CCD1: Construction Code Determination Form

RECONSIDERATION IS RESPECTFULLY REQUESTED to accept the proposed development of 84 one family attached homes to front on 34'-0" private roads (not final mapped streets) in lieu of obtaining a BSA resolution.

Ref #27429

Re: 84 New One Family Homes 7 New Hydrants with an 8" Water Main
2873 Greenfield Avenue Staten Island, NY 10304
Block No. 1126 Lot No. 33

FIRE DEPARTMENT ACCESS, HYDRANT & WATER MAIN PLAN

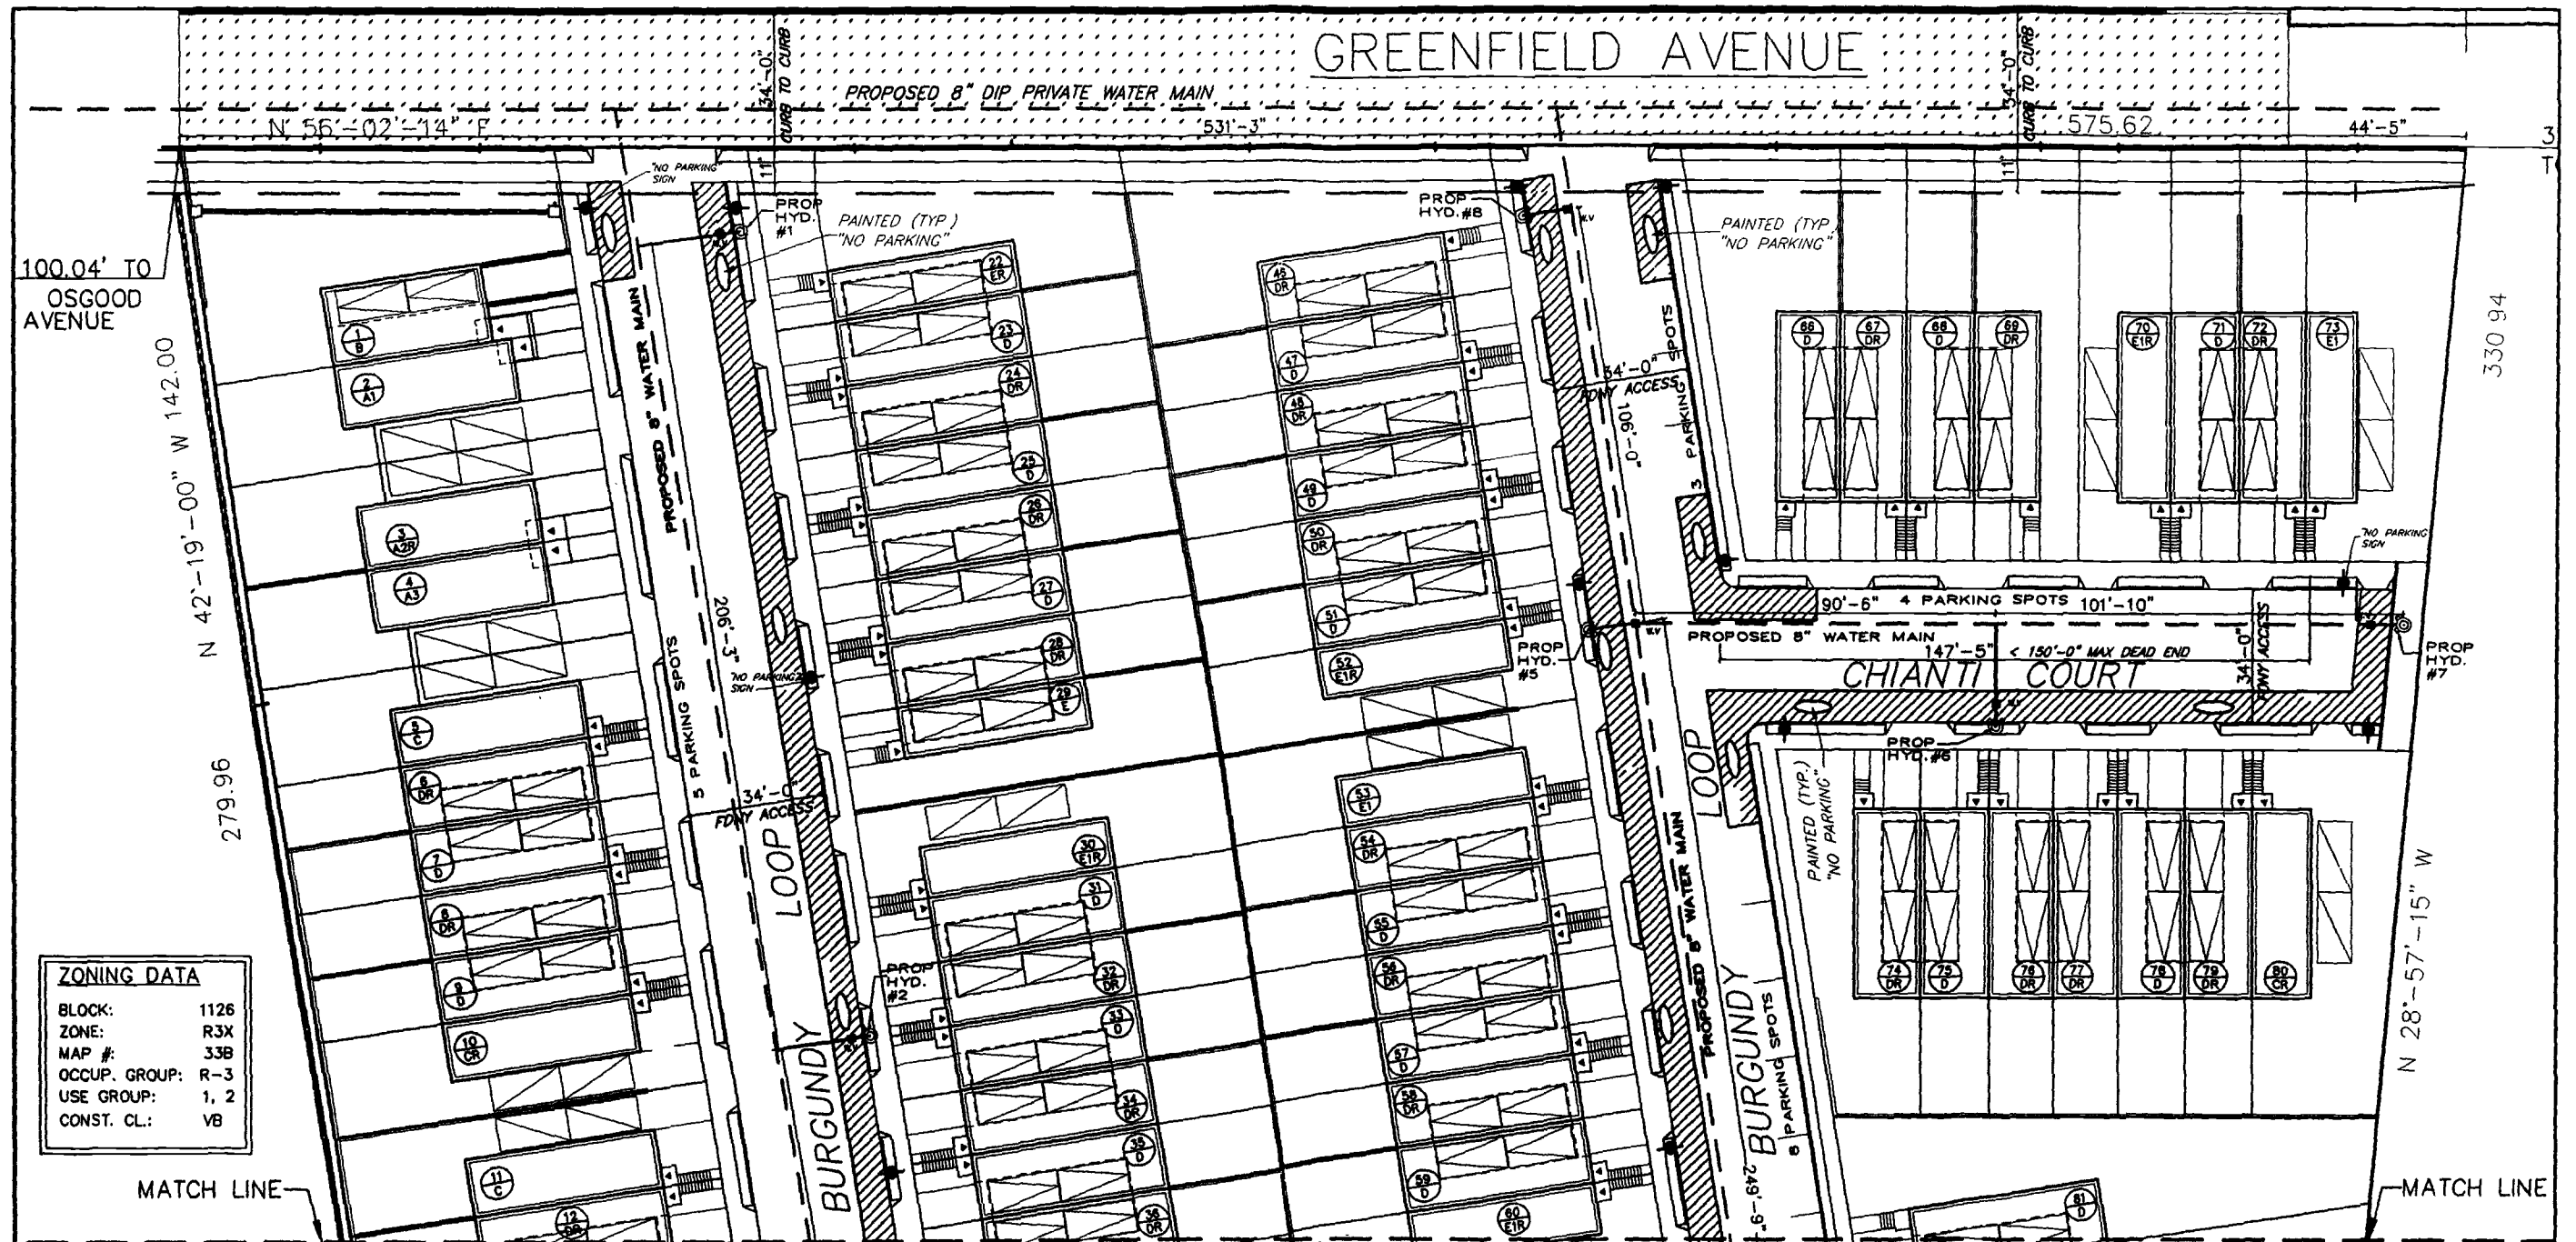
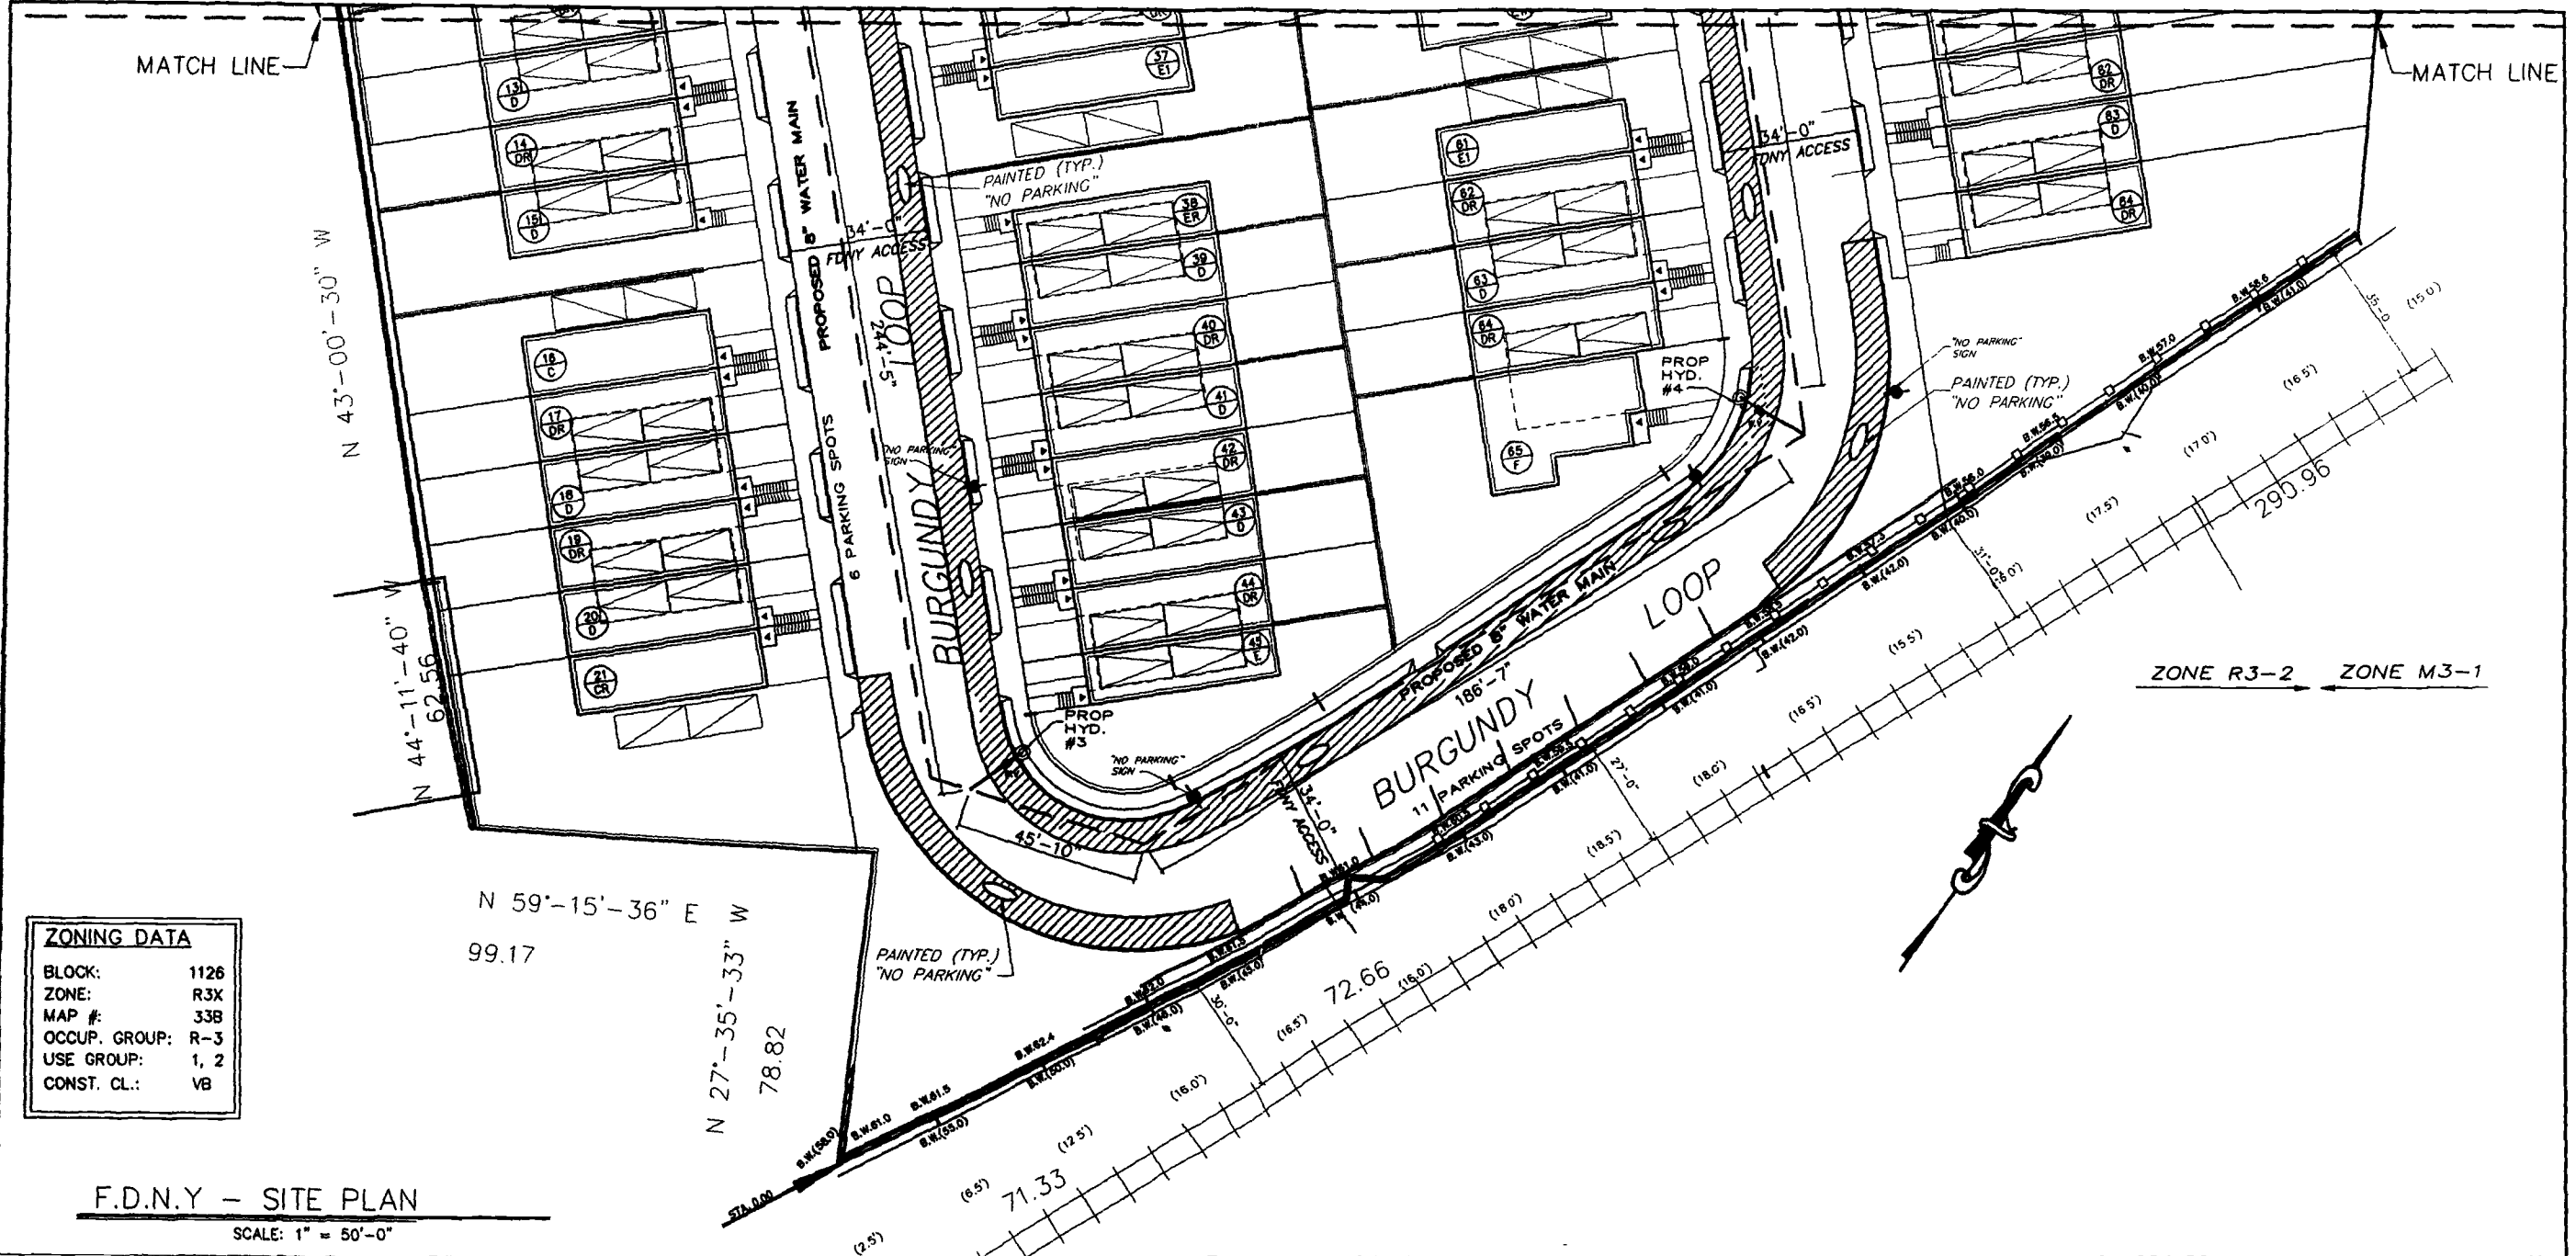
The Fire Department, Bureau of Operations has reviewed the revised site plan dated May 22, 2008 and submitted by the office of Moss & Sayad Architects on July 5th 2012 and offers no further objections. Enclosed are two stamped site plans.

1. It shall be the developer's responsibility to fully pave and improve Greenfield Avenue per DOT standards and requirements and as indicated on the approved site plan.
2. Hydrants shall be installed as indicated on the approved site plan.
3. Hydrants must be located within 250 feet of the entrance to each dwelling unit and hydrants must be on 8" or greater water mains.
4. The height of the dwelling shall not exceed 35 feet above grade plane.
5. As per Fire Code Rule 503.7, you shall place and maintain NO PARKING signs at the entrance and along one side of the fire access roads (Burgundy Loop and Chianti Court) where parking is prohibited. These NO PARKING signs shall have a minimum dimension of 12 inches wide by 18 inches high and have red letters on a white reflective background.

6. Fire Code Rule 503.2.1 states that developments shall have fire apparatus road not less than 38 feet in width and unobstructed vertical clearance of not less than 14 feet. In this rule 503.2.1 there is an exception to the 38 foot width if one of three conditions is met. You have satisfied the conditions required by one of these exceptions therefore the variance is **granted**. On the site plan the width of the access road is not less 34 feet and you have satisfied the requirements of section 26-21 of the zoning resolution which states you must provide two off-street parking spots which you have done as shown on this site plan
